KSL Planning
Environment Agency

Date: 24 June 2022
Your Ref:
Our Ref : TV/2813/14374_Rev2
email : toby@herringtonconsulting.co.uk

Project Name: Custom House River Wall

Remedial Works Report

Drawing Number:
A7752-100
Scale:
1:200 @A1
Unless Noted Otherwise
Revision

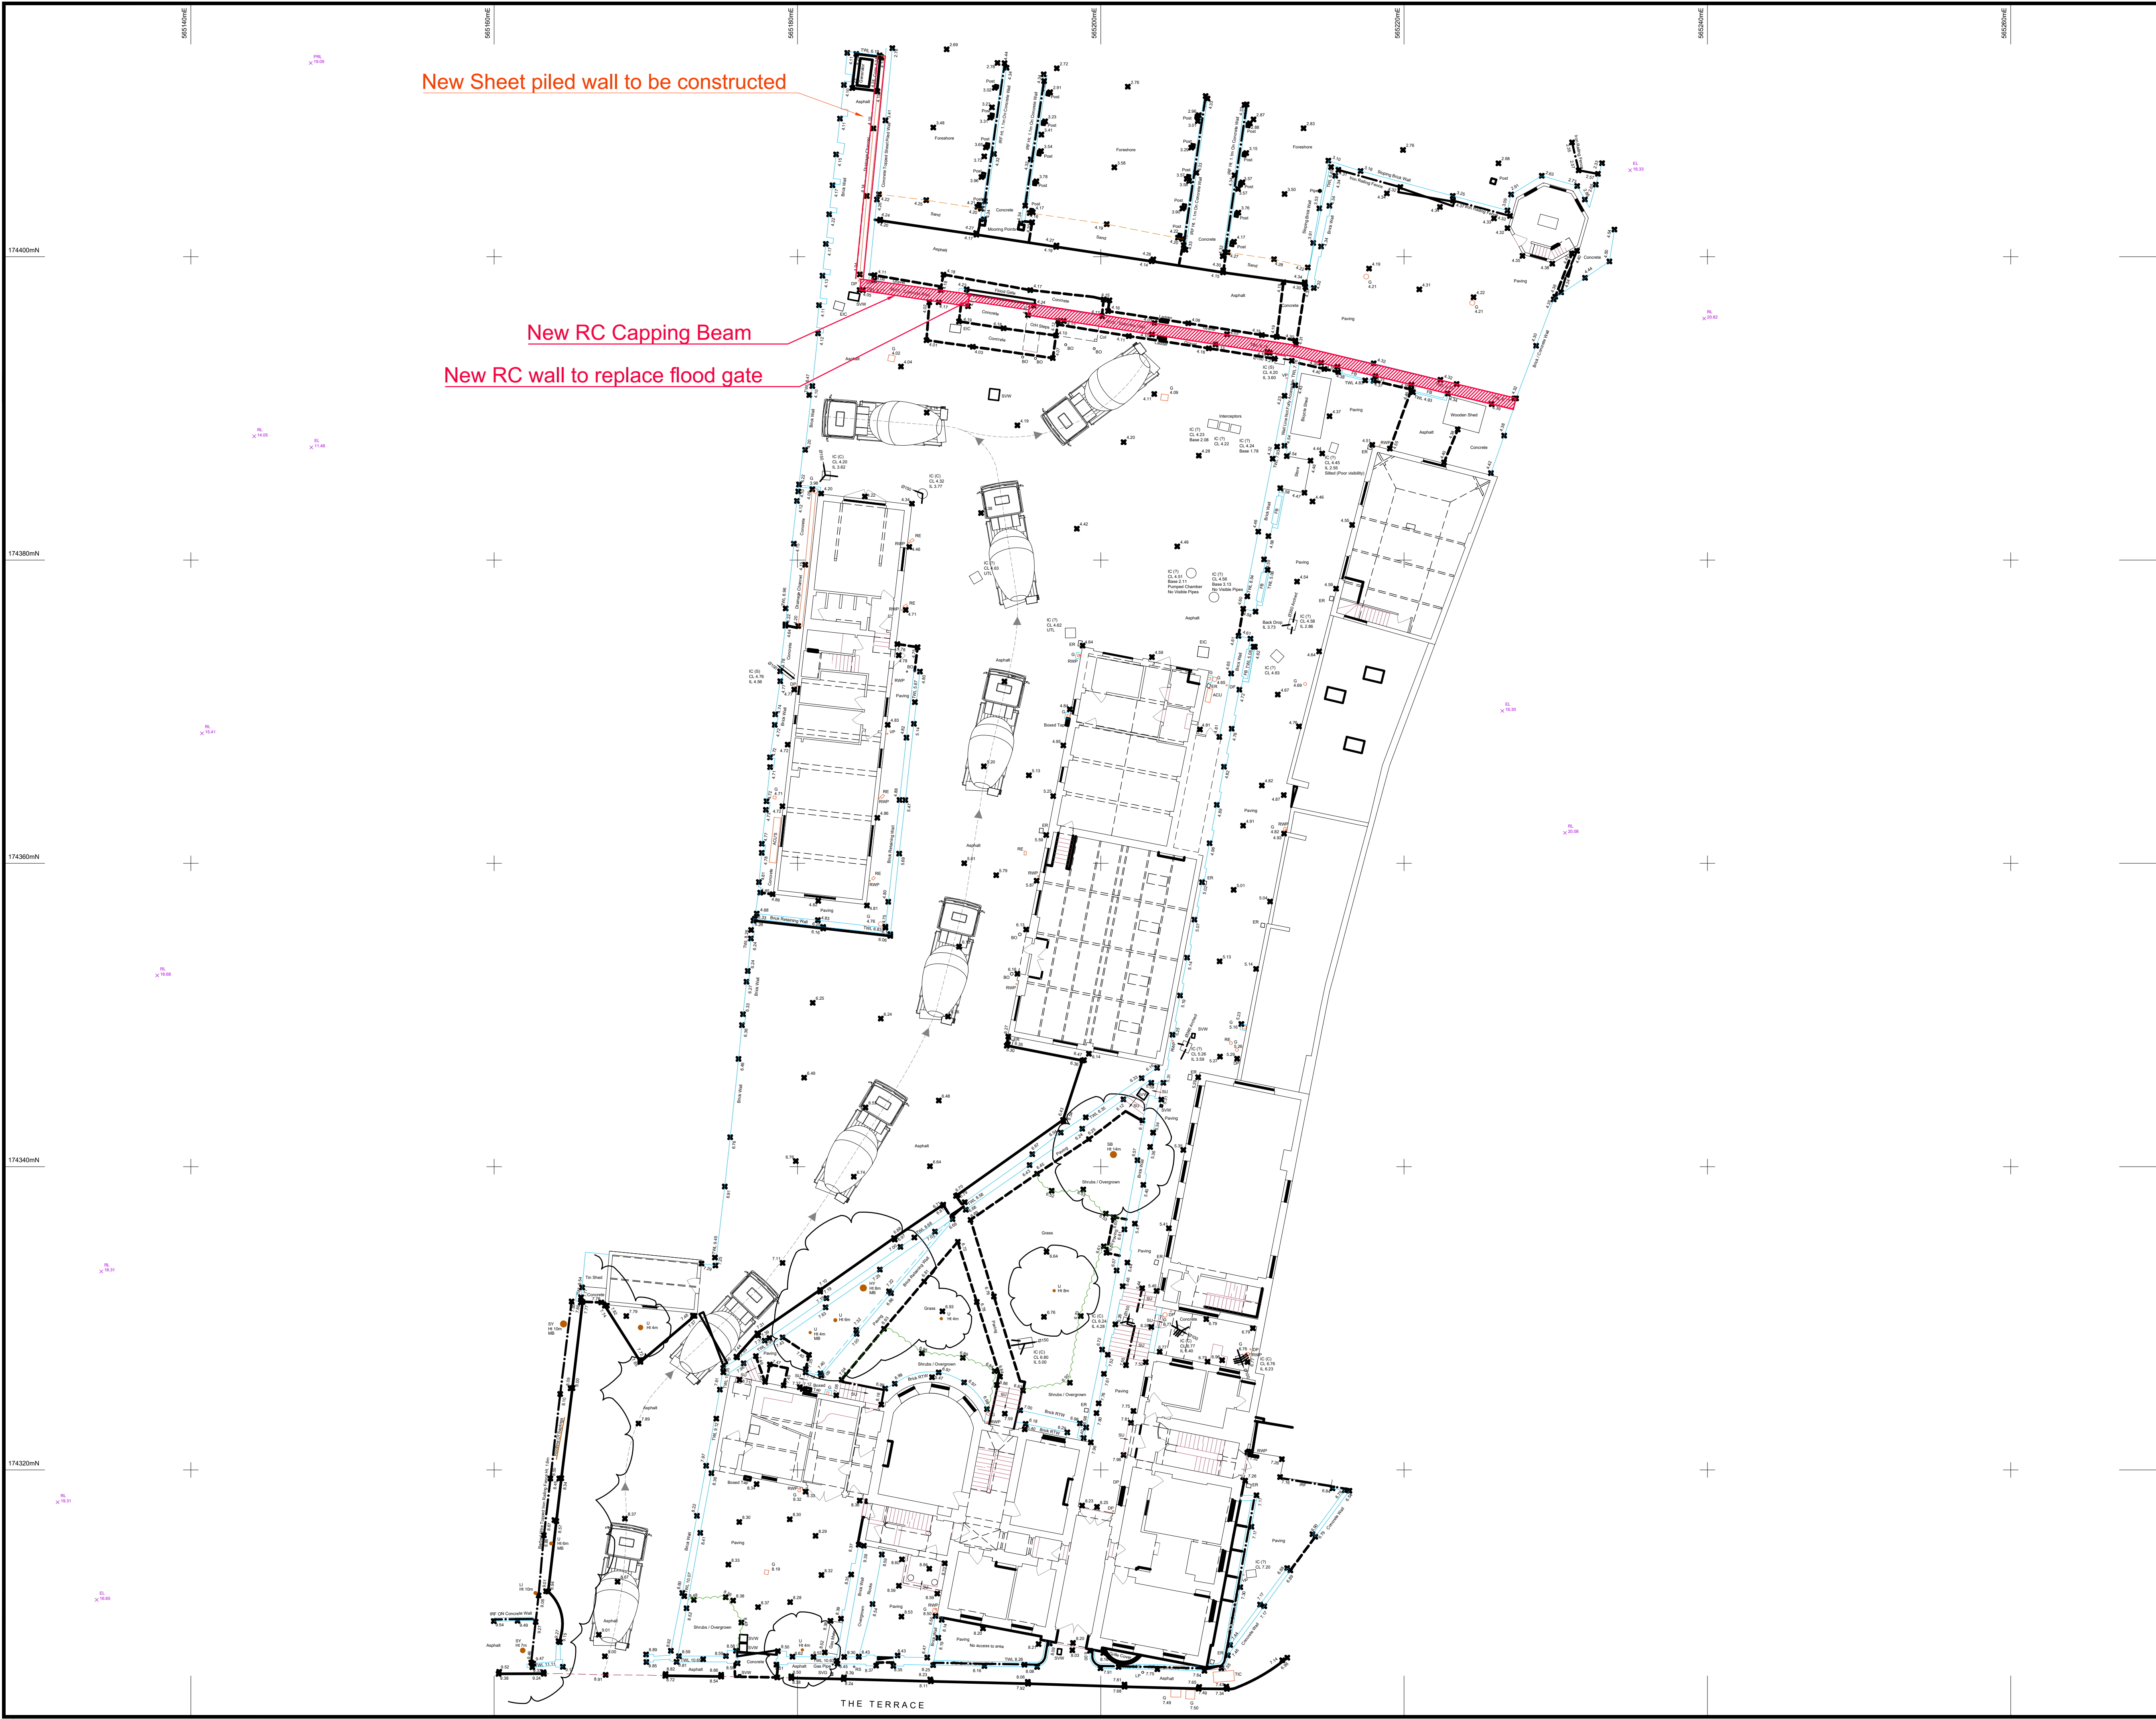
- The proposal should include a detailed plan for how defence levels will be raised to meet 2070 requirements with a 100 year design life. Based on our assessment of the submitted information, the tidal defences do not have sufficient residual life to meet the 100 year requirement or to support the load from further raising to 8.00mAOD. Therefore, a new defence with a crest of no less than 8.00mAOD should be constructed as part of this development.

- The applicant is undertaking at least the 2040 defence raising, on the basis the existing defence is demonstrated to have a life of 100 years, also accounting for the performance of the defence with the proposed 2040 raising option – a revised report must detail which option will be chosen and demonstrate buildability.

- Many of the 2040 raising suggestions add load to the flood defence. It has not been demonstrated how the flood defence could take this additional load and how this would affect its performance in achieving an 100 year life without requiring a major intervention.

Firstly, considering the existing steel sheet piled wall in the northwest of the site. This wall is to be replaced with a new wall with a minimum of 100 year design life and will be built to the TE2100 2070 level of 8.0mAODN¹. This work will take place as part of the development.

- 2.4 The proposed extent of this replacement wall is indicated on A7752-100, the details of the wall interface between new and existing will be provided during the detailed design of this wall. A 90-degree return will be provided at each end of the new sheet piled wall, to enable connection into the existing wall. Buildability is also demonstrated in Appendix D.

Drawing Number: A7752-110

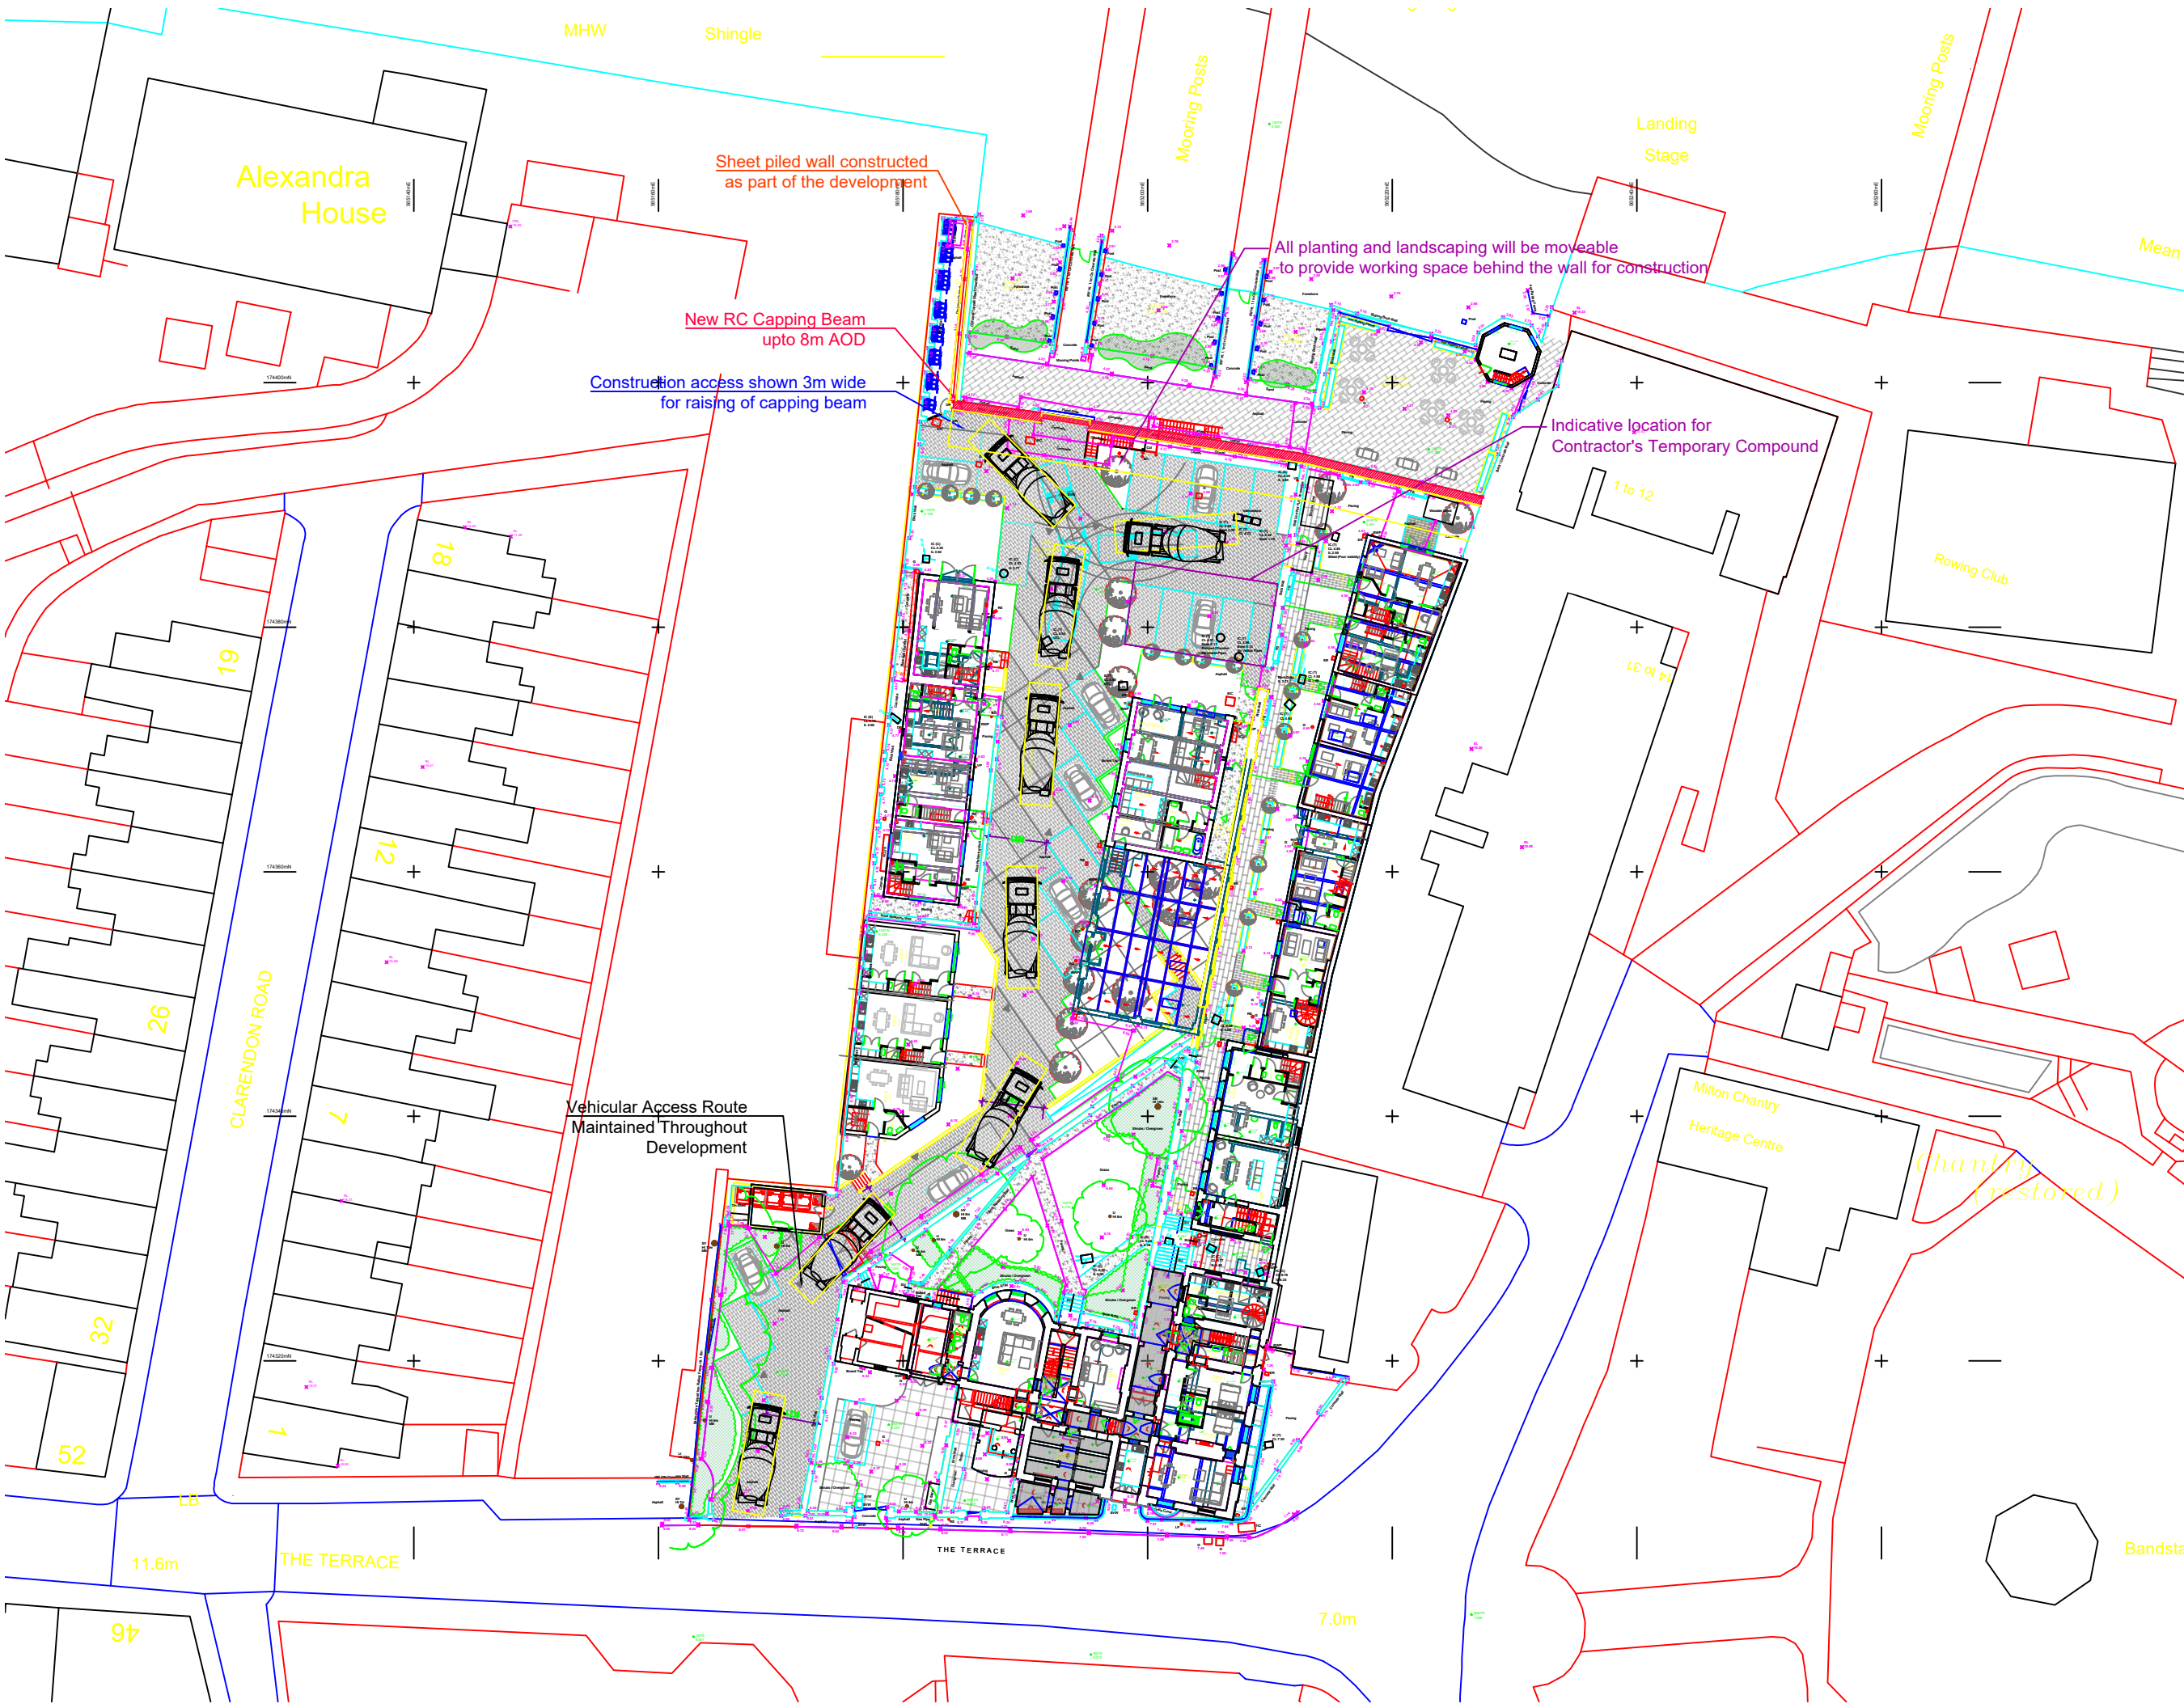
- Where the 2040 raising option employs space behind the flood defence (e.g. concrete upstand wall) we need to understand how much space will be taken up so this can be used in the assessment of space available behind the flood defence for the 2070 raising.

- The 2040 and 2070 raising is being looked at completely separately – the 2070 raising proposal must account for any changes that have been made as part of the 2040 raise as this could impact the requirements for the 2070 raise.

- 3.3 The initial raising of 6.9m AOD is to be carried out as part of the development by increasing the height of the existing reinforced concrete capping beam to 6.90m AOD. This will be done by drilling and fixing dowel bars into the existing capping beam, to create a key, and formwork shuttering around the existing capping beam, fixing new reinforcement and pouring concrete to create the higher capping beam. These works carried out as part of the development. With reinforcement designs provided during detailed design.

- 3.5 Both of these raising proposals, do not require any additional space behind the existing wall. Refer to drawings A7752-110 & 120 and sections A-A & B0B within Appendix A. The special requirements have been verified using the as built drawings. No additional space for additional support is necessary.
